UNION CARBIDE CORPORATION

Ref: (a) UCC Ltr. 12/28/78⁷ Application To Amend SNM-639.

Our letter of application (Ref. (a)) is hereby changed in accordance with discussions held between UCC & USNRC regarding assurance of criticality safety.

TOLERANCES ±	UNION CARBIDE CORPORATION CORPORATE RESEARCH LABORATORY TUXEDO, NEW YORK		
DRAWN W.R. SMAY '78	STORAGE RACK		
CHECKED:	SCALE: 1" = 1/4"	SIZE: A	DRAWING NO.: 101349
DATE:

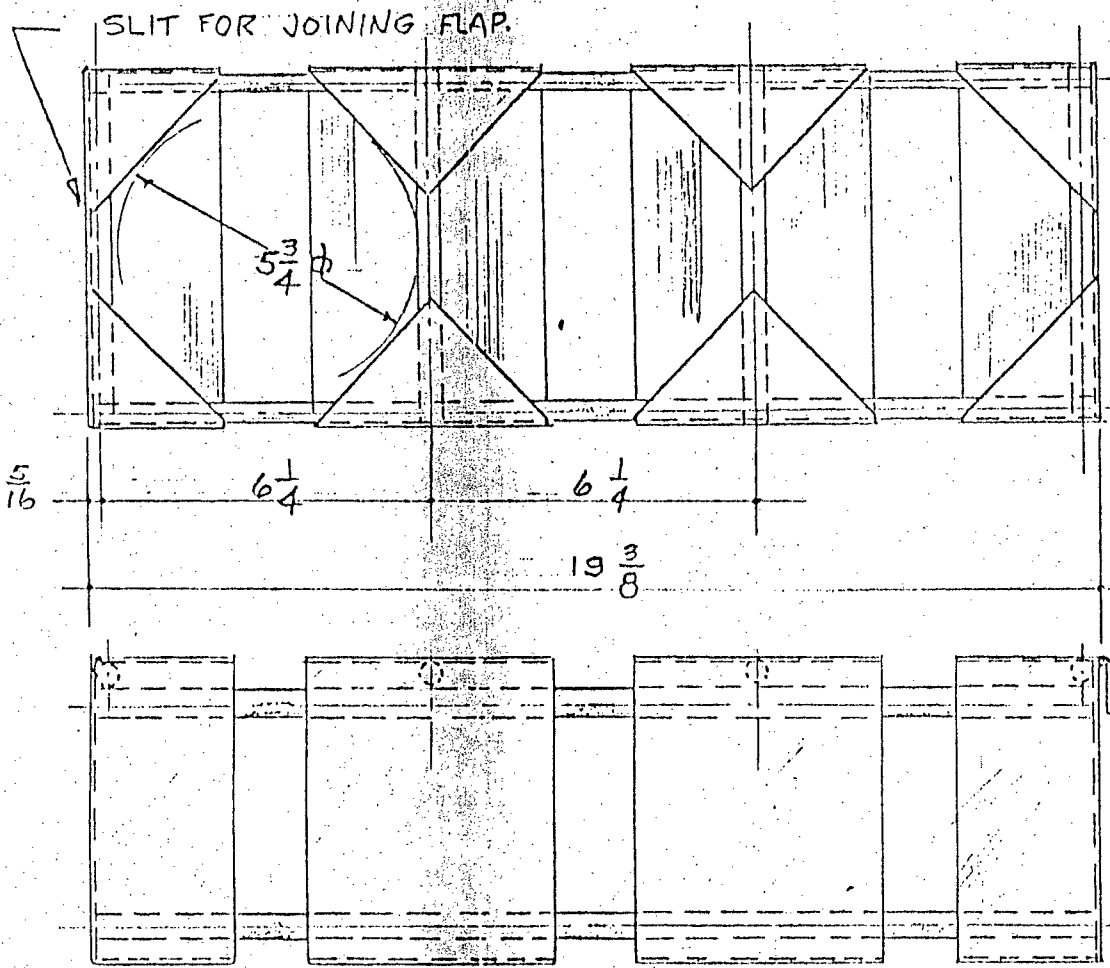
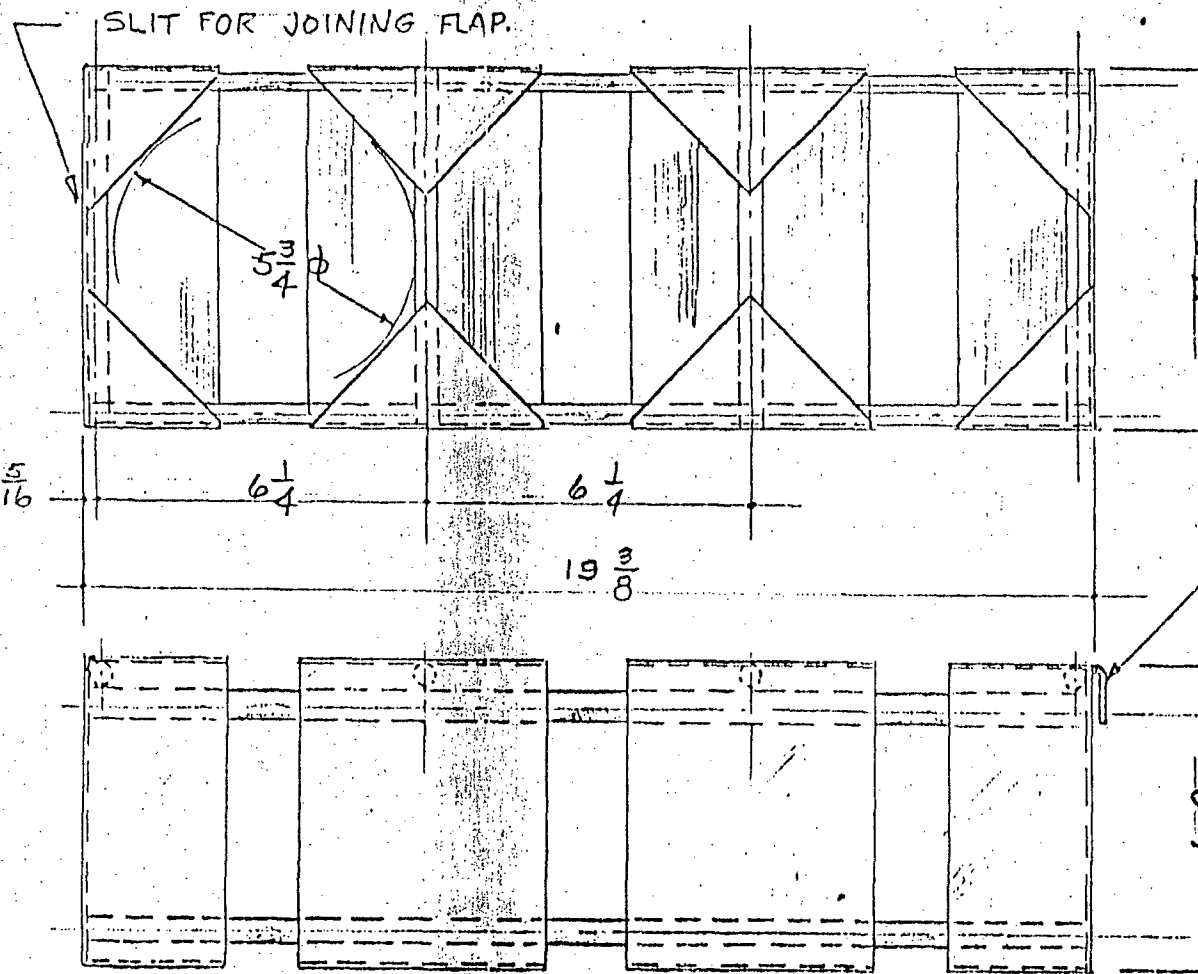
1. Each waste container is a right cylinder of aluminum metal, 5.25" OD x 0.125" wall (minimum) (I.D. < 5.0"). There is no restriction on height but each cylinder will typically be < 18" high.
2. Aluminum waste containers will be stored in a linear array within the waste storage hot cells which are not used for storage of boro-silicate glass bottles containing U-235. A diagram of a typical aluminum waste container storage is shown on the enclosed drawing.
3. Aluminum waste containers, one at a time, will be filled in an isotope processing cell and will be moved to a hot cell which is equipped with a rack for storage of the aluminum containers. For disposal, the aluminum waste containers will be placed in 55 gallon 17H steel drums (2 per drum, 300 gms U-235 max.). Arrangement of drums will be as shown in the enclosed drawing.
